**GEOLOGIC AND HYDROLOGIC SITING REPORT - ADDENDUM
 FGD SCRUBBER RESIDUE DISPOSAL SITE
 BELEWS CREEK STEAM STATION
 3195 PINE HALL ROAD
 BELEWS CREEK, NORTH CAROLINA
 S&ME Project 1054-04-955**

Subject: Duke Power – Belews Creek Steam Station
Craig Road FGD Scrubber Residue Landfill Application
Response to November 3, 2005 Comments

RE: Comments to Revised Site Geologic and Hydrologic Siting Report
Duke Power FGD Scrubber Landfill
Belews Creek Steam Station
S&ME Project No. 1054-04-955

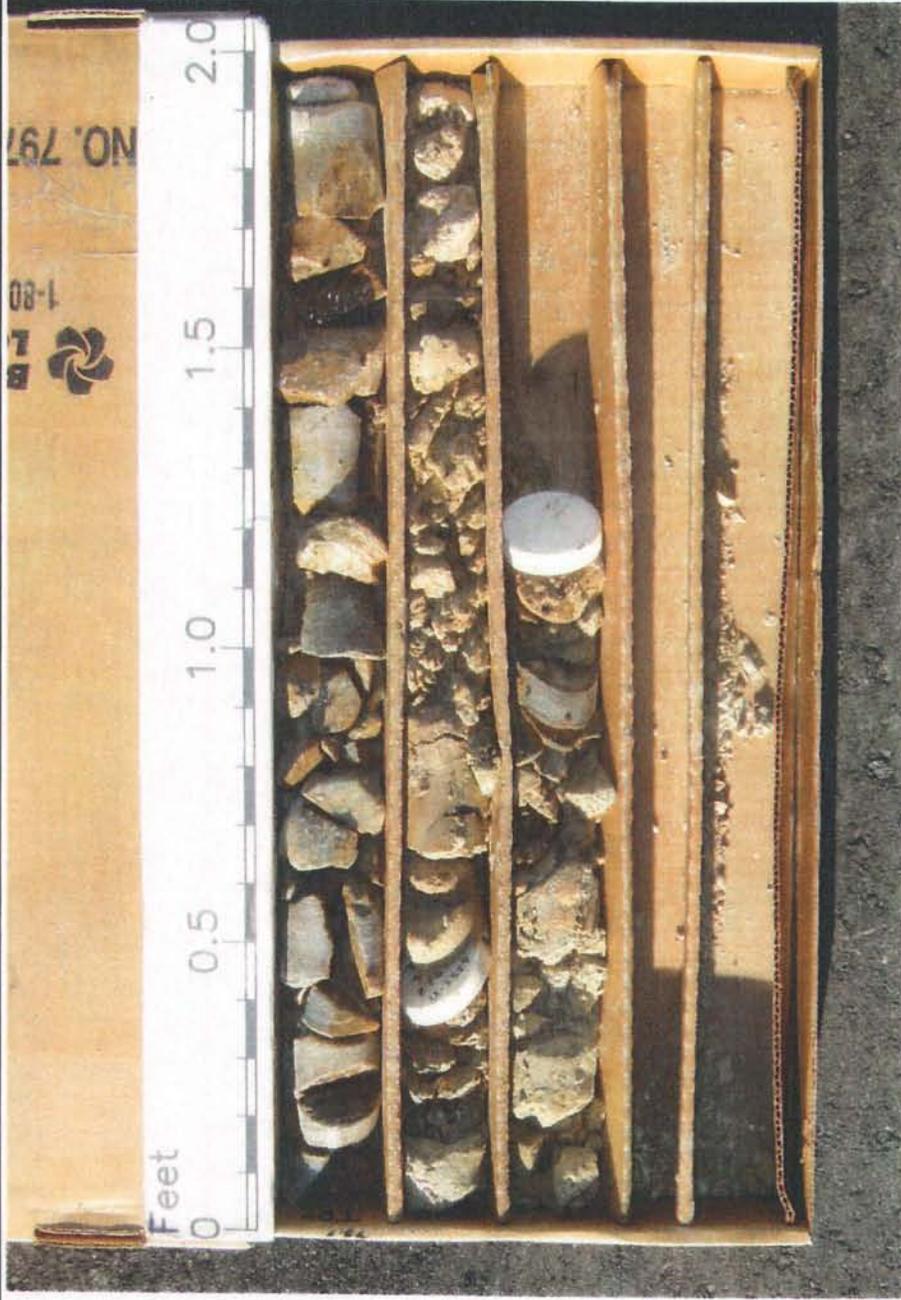
<i>Cross Section</i>		<i>Cross Section</i>	<i>Boring log profile</i>
<i>Drawing' #</i>	<i>Boring Log #</i>	<i>Depth to</i>	<i>Depth to</i>
		<i>Top of Rock, bls</i>	<i>(Auger Refusal) bls</i>
*H-H' #11	BC-3	54.5 feet	38.0 feet
*H-H' #11	BC-5	53.5 feet	46.0 feet
*A-A' #4	BC-8	Top of rock not depicted	25.2 feet
*A-A' #4	BC-9	24 feet	13.8 feet
*B-B' #5	BC-10	41.5 feet	38.5 feet

The review of boring log BC-10 indicated that auger refusal was encountered at a depth of 38.5 feet. The review of the boring log and core sample documentation indicate that the top of rock is at 38.5 feet and the top of rock elevation depicted on cross section B-B' is revised from 41.5 to 38.5 accordingly. See the photograph of rock core sampled from BC-10 attached.

BC-15 Static Water Levels
Belews Creek FGD Scrubber Landfill
S&ME Project 1054-04-955

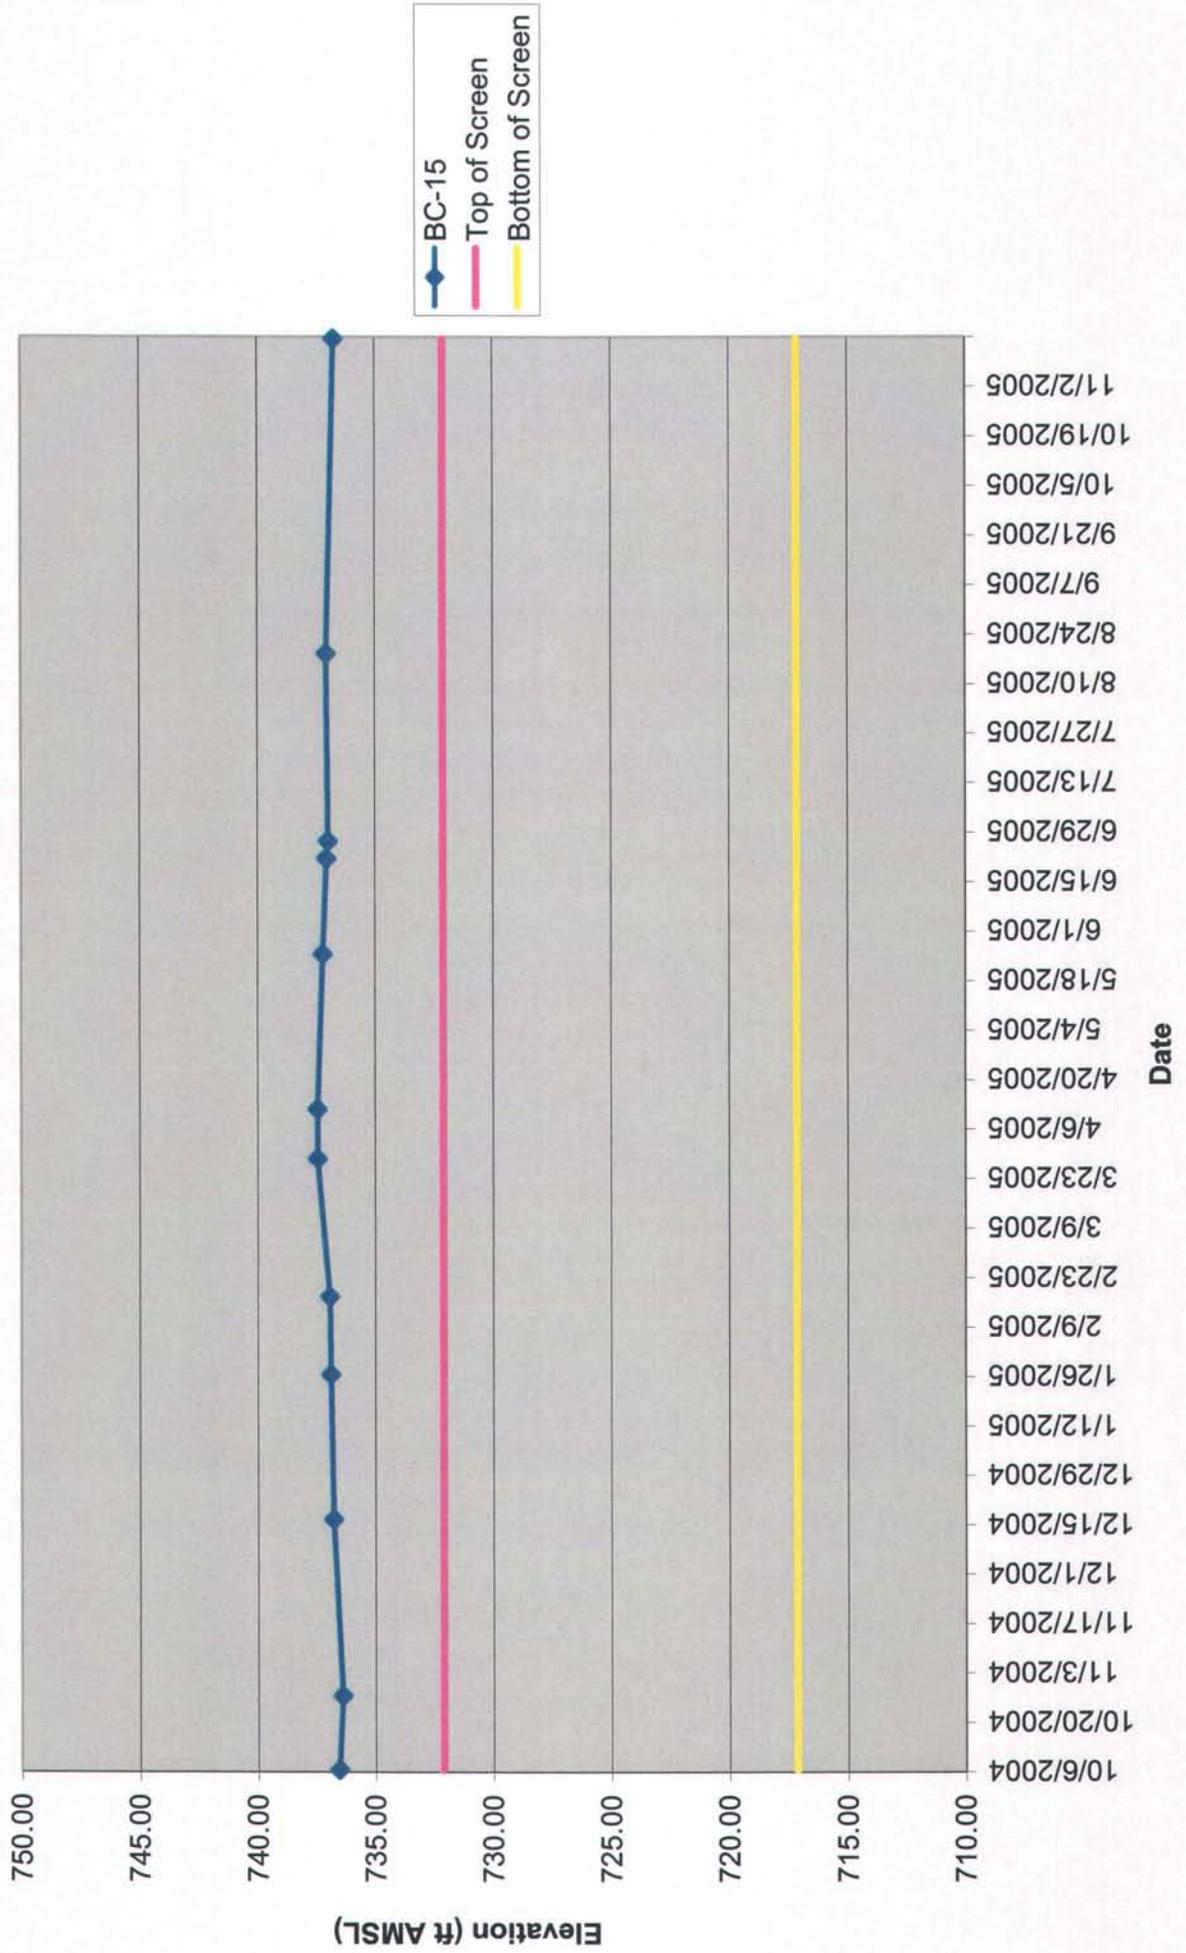
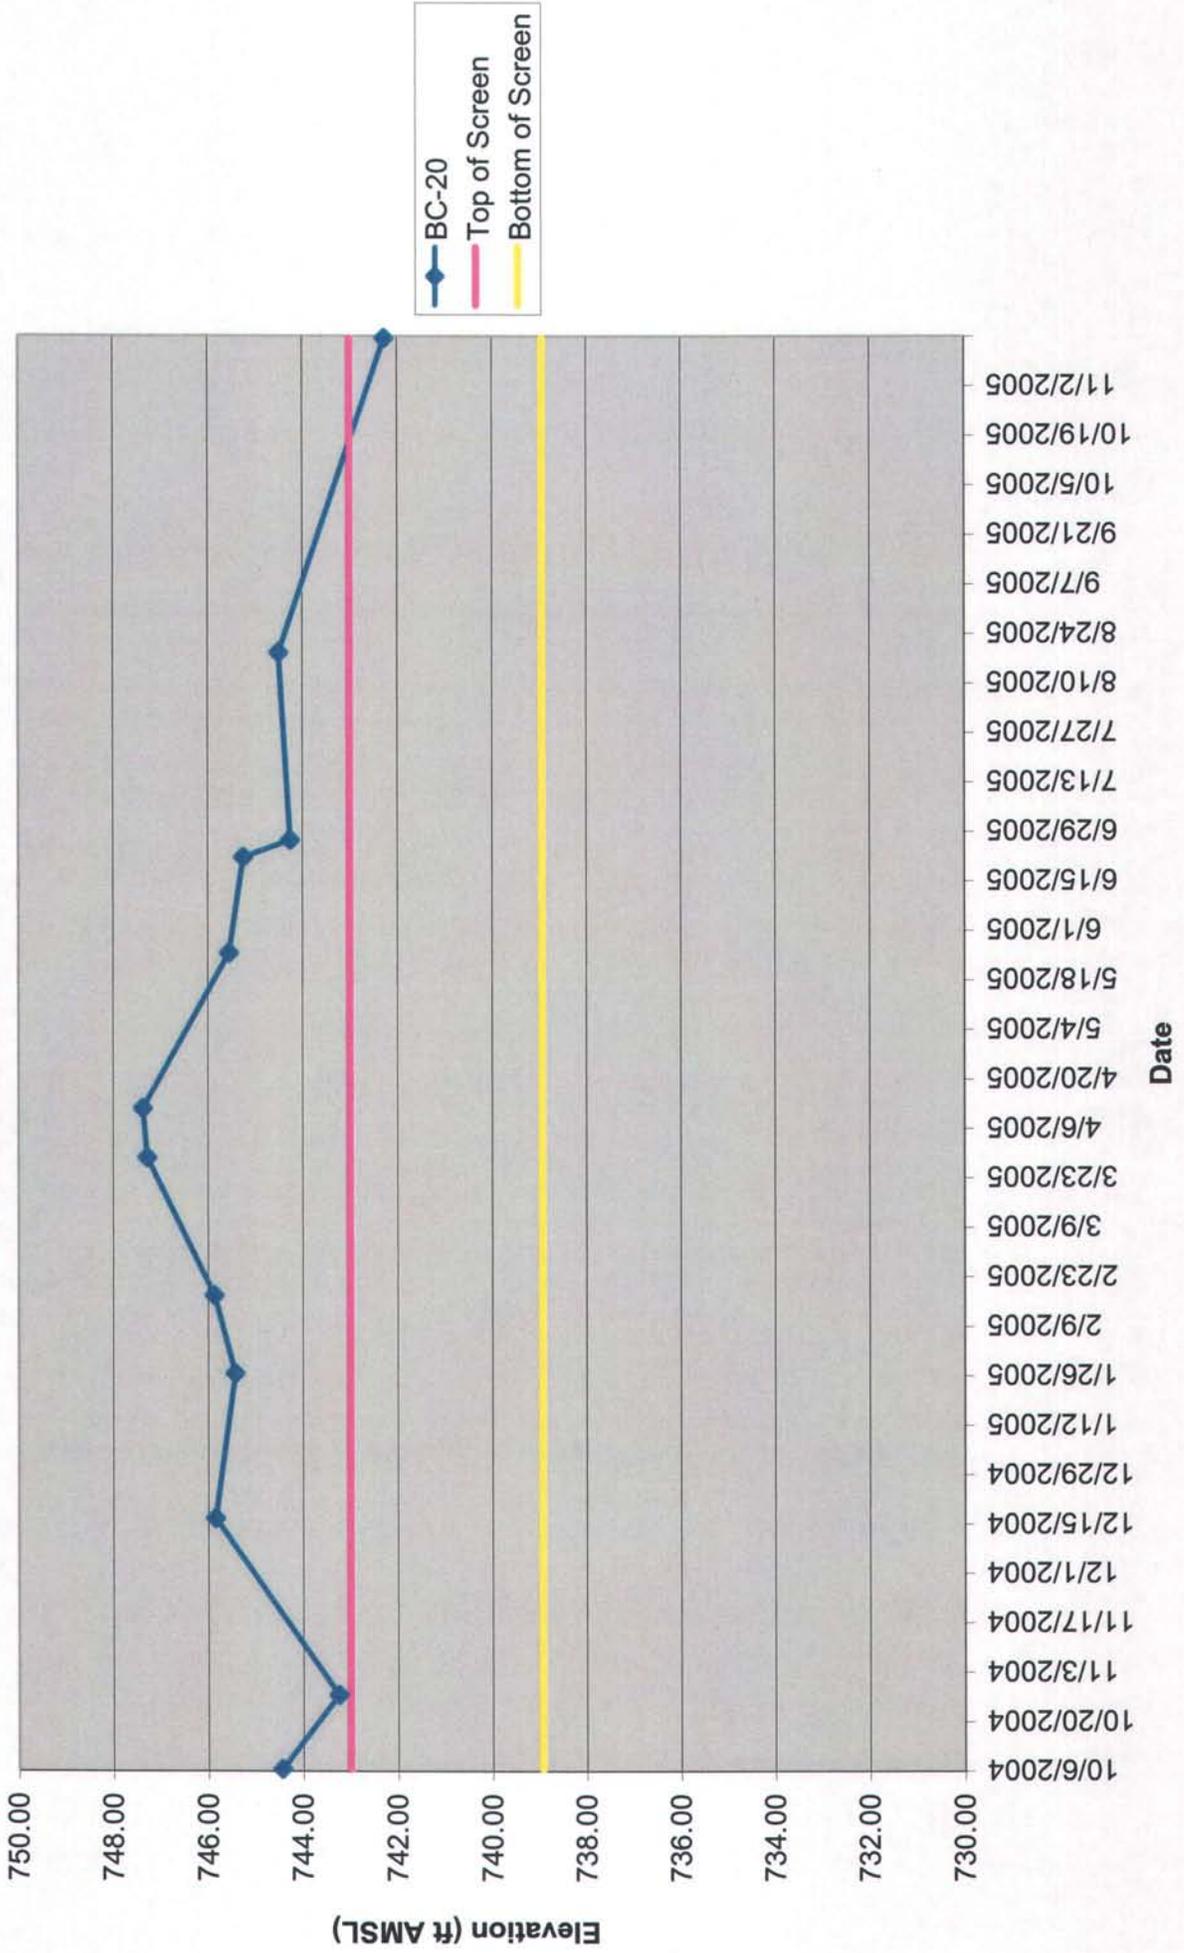
SWS Response: Existing monitor wells, BC-15 and BC-20 may be invalid for ground water quality monitoring purposes if water levels continue to be above the well screens. According to the boring logs for these wells, the water level symbols depict water level readings (24 hours after well completion), above the well screens. In most situations for ground water quality sampling purposes, the ground water monitoring well screens should bracket the water table. These subject wells may have to be abandoned or not used for monitoring ground water parameters, depending on subsequent water level data results. Please submit any recent groundwater level data, since 10/27/04 for these two (2) wells. If no data is available, then measure, record, and submit water level results from these wells.

S&ME Response: Groundwater levels taken at monitor wells BC-15 and BC-20 from October 6, 2004 through November 15, 2005 are summarized on Table 2, and graphically displayed on time-series graphs included in the Appendix. The well screen elevations are also shown on Table 2 and on the time-series graphs. Monitor wells BC-15 and BC-20 should be abandoned and should not be used as part of the water quality monitoring network. To complete the monitoring network, two
